Imray Correction Notice

IC2800-3

Chart 2800

Edition 2021

Block correction for 2800 Tidal streams
around the north of Jura
ILNW 184/22

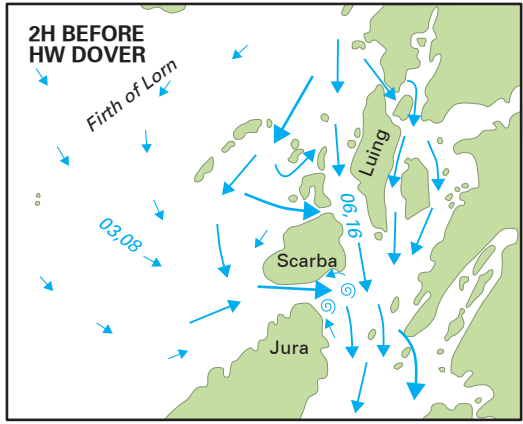
3 Tidal streams around the north of Jura (*certain copies*)

Insert block correction tidal stream diagram around Jura 2H Before HW Dover replacing the duplicate 1H Before HW Dover diagram (ILNW 184/22)
